# **BWR OWNERS GROUP**

**Position on NRC Regulatory Guide 1.97, Revision 2**

**July 1982**

FIGURE 3  
THERMOCOUPLE TEMPERATURE TIME HISTORY  
AT THREE AXIAL POSITIONS

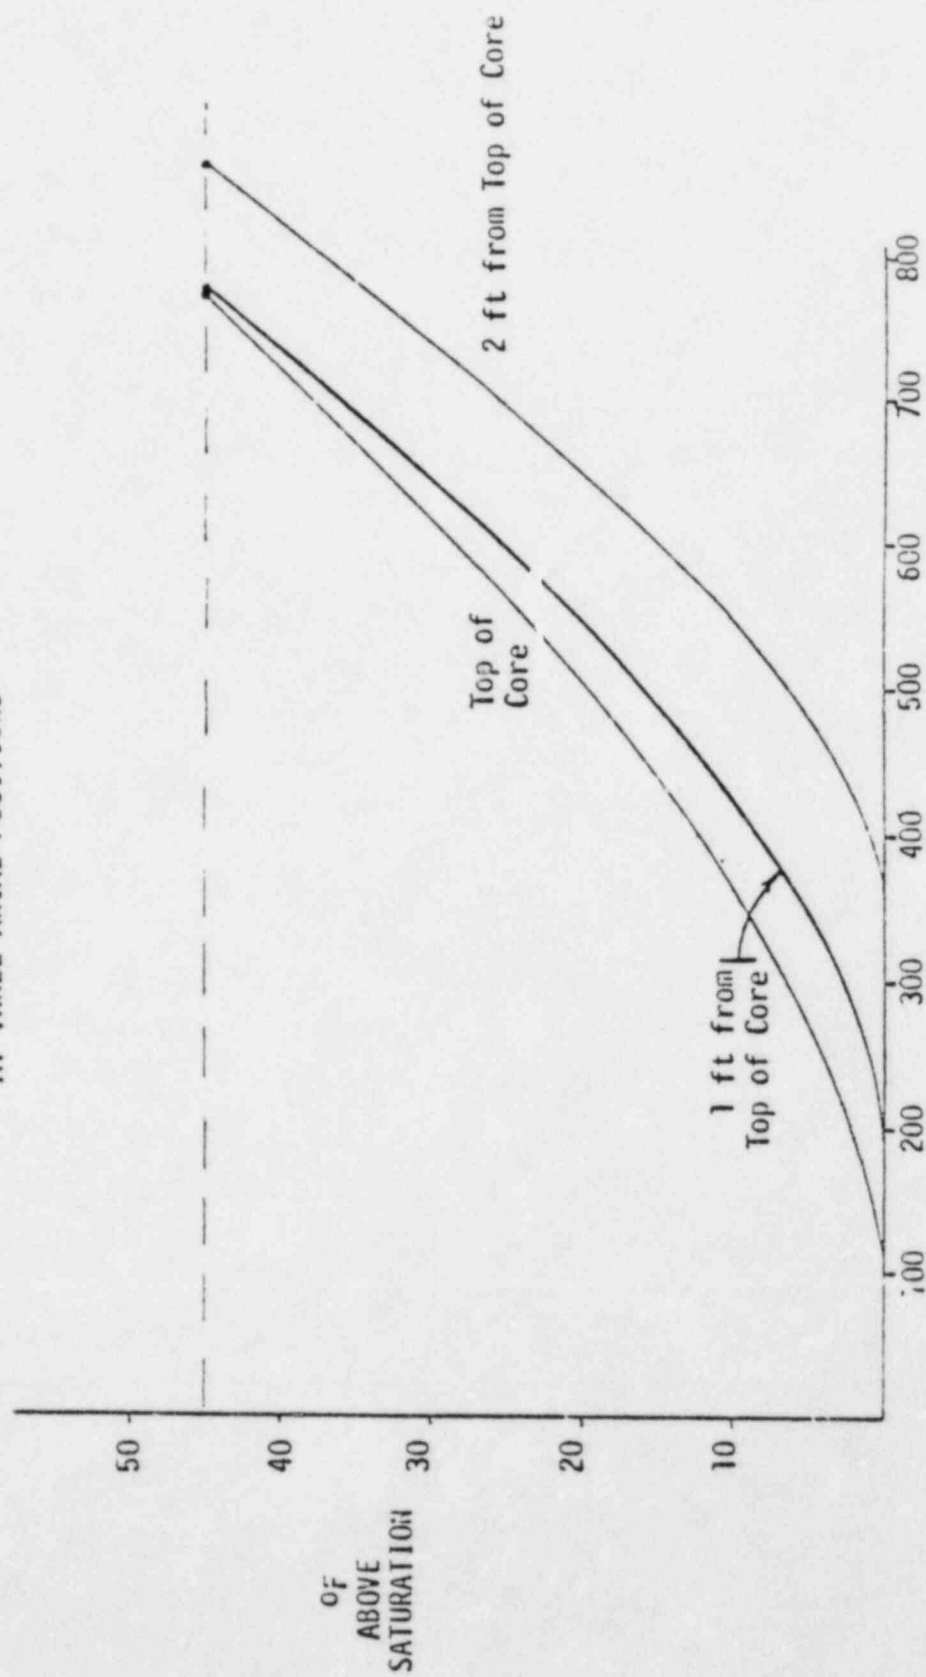
Figure 3 shows the calculated temperature response for three axial thermocouple positions, the top of the core, 11 ft and 10 ft. elevations. This graph shows that the response times are on the order of 13 minutes. Figure 3 also shows that the optimum location for the thermocouple is near to the top of the core, although the response time (measured from the start of core uncover) is not a strong function of position. After examining Figure 3 it was decided to use a thermocouple location 1 ft from the top of the core for all further calculations.

FIGURE 6  
RESULTS OF NRC CALCULATION

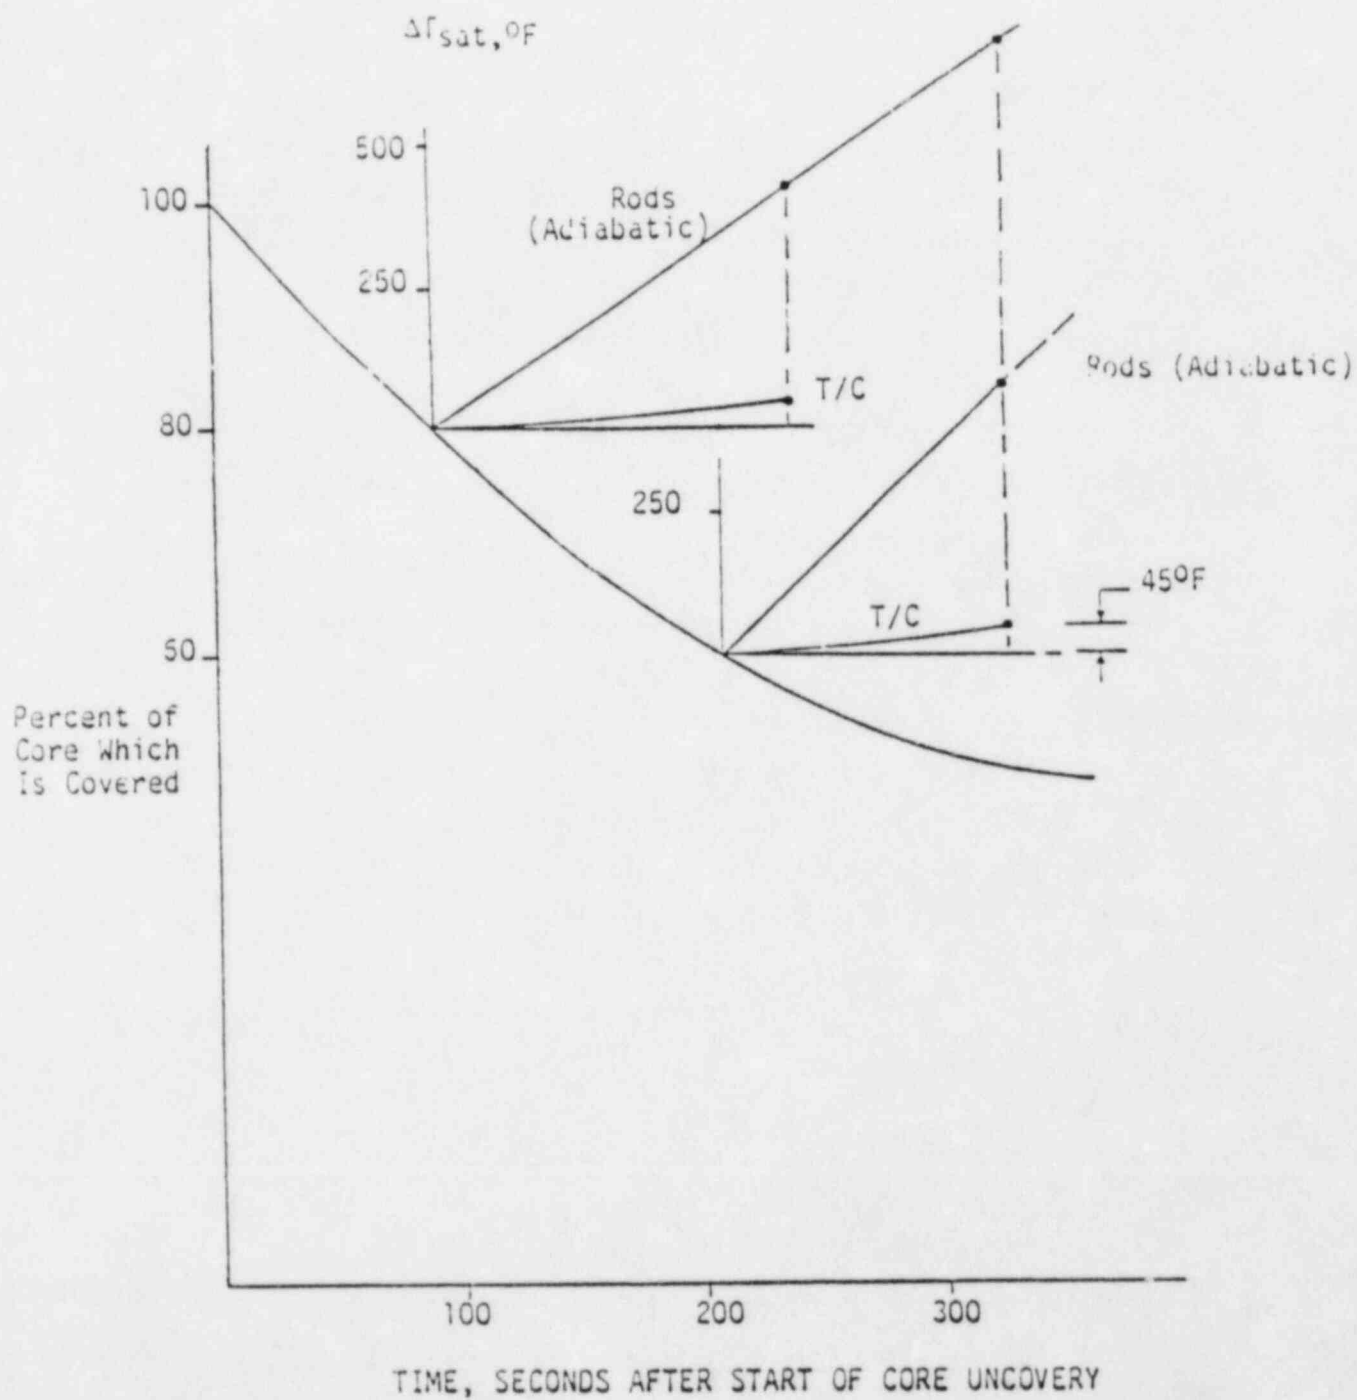
As part of this project, we have reviewed a calculation of the thermocouple response time by the NRC office of Nuclear Regulatory Research. Their calculation assumed a 2% of rated uniform axial power input and no convective heat transfer. They assumed that convection and radiation losses from the rods would be negligible. Their results are plotted in Figure 6. The adiabatic rod heat up rate which they calculated was about  $2.7^{\circ}\text{F}$  per second at the 80% of core height elevation (about 9.7 ft above B A F) and  $3.8^{\circ}\text{F}$  at the 60% core height elevation. With these heat up rates their results show that a thermocouple at the 60% height would show a  $45^{\circ}\text{F}$  temperature rise 120 sec after the 60% plane is uncovered.

The simple calculation in the last section shows that the adiabatic heatup rate should be on the order of  $1^{\circ}\text{F}/\text{sec}$  rather than the 2.7-3.8 that the NRC used. However, in order to compare our calculation to theirs, we adjusted the prescram power in our code (to 8,672 megawatts from 2436) and set the convective heat transfer coefficients equal zero. These results are shown in Figure 7. They agree very well with the NRC results. Using the NRC heatup rate our code predicts that a thermocouple at the 60% height will show  $45^{\circ}\text{F}$  temperature rise 135 seconds after the 60% plane is uncovered. The NRC calculated the 60% plane would uncover after 90 sec and the 80% plane after 210 sec. Our calculations, with their assumptions, shows these planes uncovering at 110 and 242 seconds respectively.

We conclude that the essential differences between our calculation and the NRC's are the extremely high heat up rates they assumed and the fact that they neglected convection to the passing steam. Both of these differences tend to make the calculated core temperatures rise more quickly after uncover which speeds up thermocouple response. We believe our assumptions are more realistic, and our results more correct.
